February 8, 2012  
Project No. 401823001

Subject: Request for Work Plan Addendum  
Western Forge and Flange Company  
540 Cleveland Avenue, Albany, California  
SLIC # RO0003009 / Geotracker Global ID # T10000001598

<i>Ninyo &amp; Moore</i>		PROPOSED BORING LOCATIONS	FIGURE
PROJECT NO.	DATE	WESTERN FORGE & FLANGE 540 CLEVELAND AVENUE ALBANY, CALIFORNIA	<b>6</b>
401823001	2/12

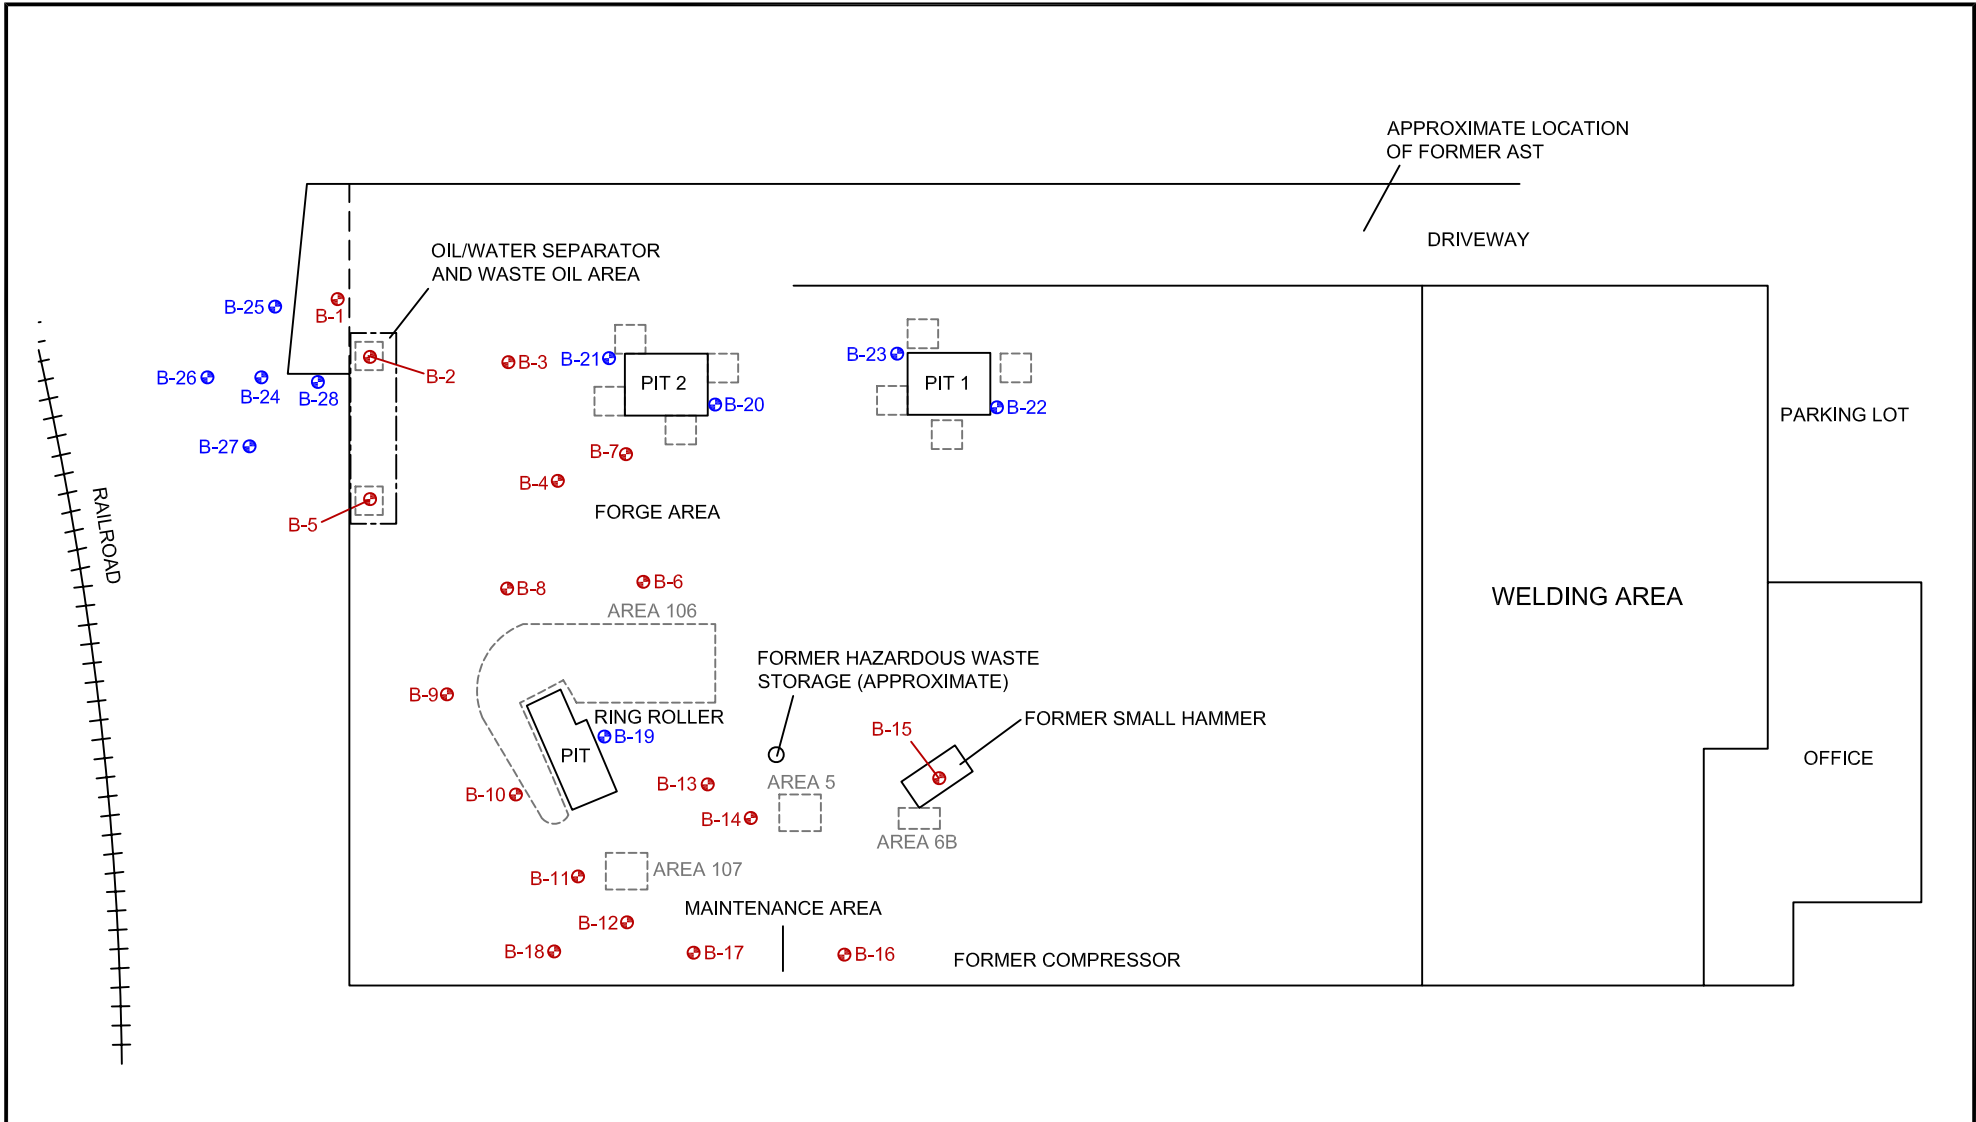
1. **Request for additional sample locations** – Ninyo & Moore generally agrees with the ACEH request for additional soil borings, with some exceptions. Additional borings have been added to the Work Plan at the following locations, and are indicated on the attached revised

- a. East of the Ring Roller Pit (RRP) – Boring B-19 has been added.
- b. Pit 1 and 2 – Borings B-20 through B-23 have been added.
- c. Roof Blow Down – Due to poor documentation of previous sampling events, the ACEH has requested additional borings and sample analyses in the area outside of the northwest corner of the building, previously known as Area 111. The ACEH has requested step-out sampling with soil sampling from multiple depths, groundwater from each boring, and analysis for CAM 17 metals, hydrocarbons and polychlorinated biphenyls (PCBs).

Borings B-24 through B-28 have been added to the Work Plan, where borings B-25 through B-28 are the step-out locations to boring B-24. Due to the physical constraints presented by the building, the fence along the railroad track, and the assumed easement of the railroad track, the step-out borings are approximately 10 feet from B-24. Based on measurements taken at the site, the maximum distance from the edge of the building to the railroad fence is approximately 13 feet. Therefore, the following sampling plan is proposed in the Roof Blow Down area :

- d. The ACEH has requested two soil borings with soil and groundwater samples near and downgradient of the former diesel underground storage tank reportedly located in the driveway near the front (east) side of the building. Please note that of former diesel tank located in this area was a 1,000-gallon above ground storage tank (AST). According to the Executive Report of Closure (CDMS 2009), the AST is listed on the Hazardous Materials Inventory and when the facility was shut down in 2007 and equipment was removed, the AST was returned to the vendor. Ninyo & Moore has inspected the area of the site where the AST was located and there is no oily staining on the concrete surface,

- Advance boring B-24, collect soil samples at 0.5 feet below ground surface (bgs), 1.0 feet bgs, and every foot until groundwater; conduct CAM 17 metals (including hexavalent chromium) and total petroleum hydrocarbons (TPH) as hydraulic oil analyses on the first three vertical samples from surface to 2.0 feet bgs. Deeper samples would be placed on hold, pending results of the shallower samples. Upon receipt of laboratory results, the sample with the highest TPH as hydraulic oil (above environmental screening levels [ESLs]) would be analyzed for PCBs.

- Collect groundwater samples from boring B-24 for analyses of CAM 17 metals and TPH as hydraulic oil.
  - Advance borings B-25 through B-28, and collect soil samples at 0.5 feet bgs, 1.0 feet bgs, and every foot until groundwater and place the samples on hold, pending results from the B-24 samples. In the event that samples from boring B-24 contain analyte concentrations above ESLs, a maximum of six soil samples from the step-out borings would be analyzed for CAM 17 metals, TPH as hydraulic oil and/or PCBs.

- Collect groundwater samples from one boring downgradient of boring B-24 (B-26 or B-27), and place the samples on hold pending the results from the groundwater samples collected from boring B-24.

or other evidence indicating that this area was impacted by the AST. Therefore, Ninyo & Moore proposes that no soil borings are advanced in this area.
